# Access Audit Site Report

**Lake Livingston State Park**  
**300 State Park Rd 65**  
**Livingston, TX 77351**  
**Accessibility Evaluation**  
**Inspection Date: 11/08/2021**  
**Inspectors: Tanya Scheibe**

July 28, 2023

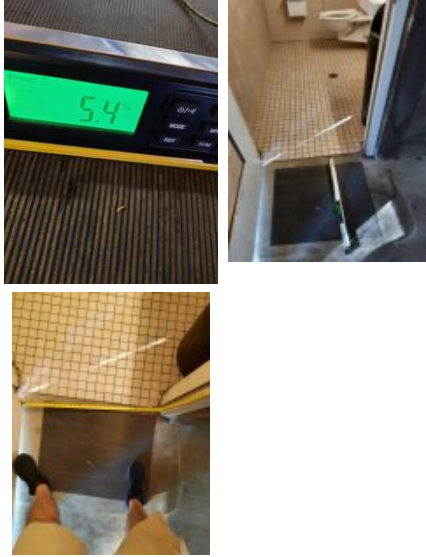
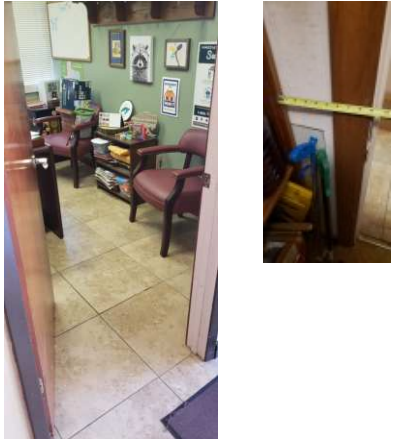
Finding Number	Area Description	Lat/Long	Finding	As Built	Recommendation	Citation	Photos	Figure
19	Headquarters: Headquarters Unisex Restroom	[30.65691, -95.00105]	The water and drain pipes under the lavatory are not adequately insulated. Water supply and drain pipes under lavatories and sinks shall be insulated or otherwise configured to protect against contact. There shall be no sharp or abrasive surfaces under lavatories and sinks.	Sink lacks insulated pipes	Insulate exposed pipes under one sink	2015 ABAAS Section: 606.5  2012 TAS Section: 606.5  2010 ADAS Section: 606.5		
20	Headquarters: Headquarters Unisex Restroom	[30.65691, -95.00105]	The required 56 inches by 60 inches clear floor space for the water closet has been obstructed. The clear floor space around the water closet shall be 60 inches minimum measured perpendicular from the side wall and 56 inches minimum measured perpendicular from the rear wall.	Lacks 60" clear floor space around toilet - 50.75" to sink, 54.5" deep	Renovate restroom to provide 60" by 56" clearance around the toilet.	2015 ABAAS Section: 604.3.  2012 TAS Section: 604.3.1  2010 ADAS Section: 604.3.1

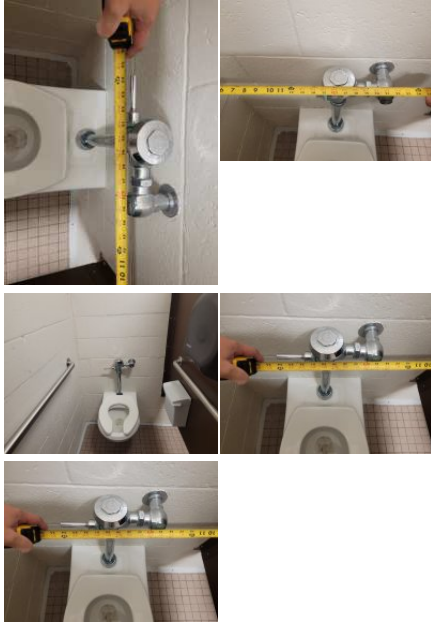
99	Hercules Club Loop: Hercules Club Loop Men's Restroom	[30.6517853 , -95.003453 3]	The side grab bar is not long enough. The side grab bar must extend at least 54 inches minimum beyond the rear wall and start a maximum of 12 inches from the rear wall. A 42 inch grab bar installed the maximum distance from the rear wall (12 inches) will leave the leading end 54 inches from the rear wall. Grab bars shall be installed in a horizontal position, 33 inches minimum and 36 inches maximum above the finish floor measured to the top of the gripping surface.	Side grab bar on partition is 36" long	Replace side grab bar with a 42" long grab bar, mounted max 12" from the rear wall at the close end and min 54" on the far end and 33" to 36" AFF.	2015 ABAAS Section: 604.5.1  2012 TAS Section: 604.5.1  2010 ADAS Section: 604.5.1

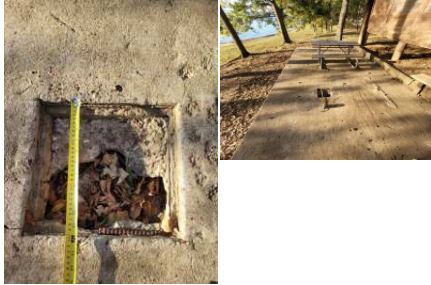
177	Piney Shores: Piney Shores Screened Shelter - 2	[30.6525294 , -95.007216 4]	The ramp run has not been provided with edge protection. The floor or ground surface of the ramp run or landing shall extend 12 inches minimum beyond the inside face of a handrail or a curb or barrier shall be provided that prevents the passage of a 4 inch diameter sphere, where any portion of the sphere is within 4 inches of the finish floor or ground surface.	Entry Ramp - lacks edge protection	Install rail along bottom edge of ramp that prevents a 4" sphere from passing through	2015 ABAAS Section: 405.9, 405.9.1, 405.9.2  2012 TAS Section: 405.9.1, 405.9.2, 405.9  2010 ADAS Section: 405.9.2, 405.9.1, 405.9

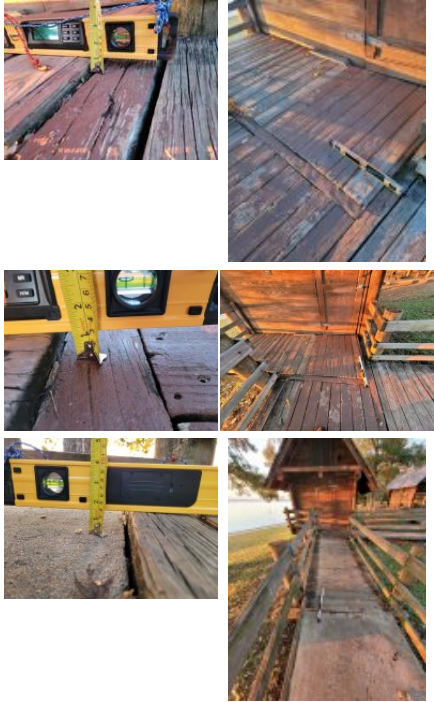
198	Piney Shores: Piney Shores Screened Shelter - 3	[30.6523968 , -95.007299 5]	There are openings in the surface of the trails, passing spaces, and resting intervals that allow the passage of a sphere more than 1/2 inch in diameter. Openings in the surface of trails, passing spaces, and resting intervals shall not allow the passage of a sphere more than 1/2 inch (13 mm) in diameter.	Gaps of .75", 1", .75", and 1" on board walk	Correct for fill gaps to max .5" as a smart practice.	2015 ABAAS Section: 1017.6

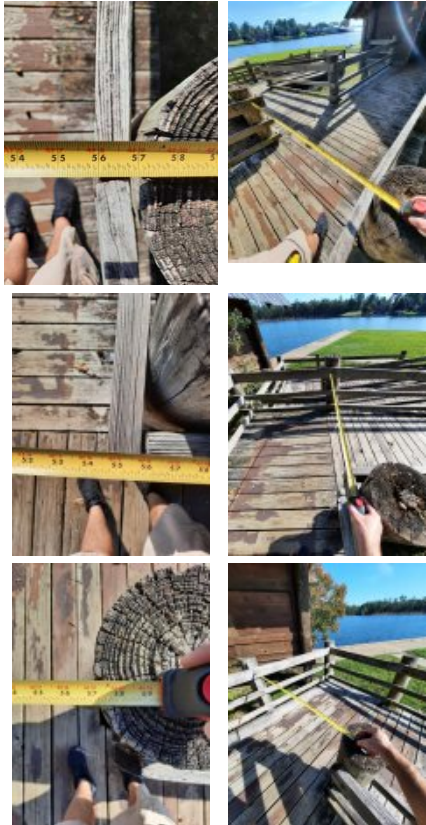
207	Piney Shores: Piney Shores Screened Shelter - 3	[30.6523738 , -95.007320 1]	Obstacles on outdoor recreation access routes, passing spaces, and resting intervals shall not exceed 1/2 inch (13 mm) in height measured vertically to the highest point. EXCEPTION: Where the surface is other than asphalt, concrete, or boards, obstacles shall be permitted to not exceed 1 inch (25 mm) in height measured vertically to the highest point.	CILs of 1" and 1" at shelter and 1.5" at boardwalk/sidewalk	Repair, bevel or ramp CIL along the ORAR to max .5" or 1" for surfaces other than concrete, asphalt or boards as a smart practice.	2015 ABAAS Section: 1016.5, 1016.5 EXCEPTION
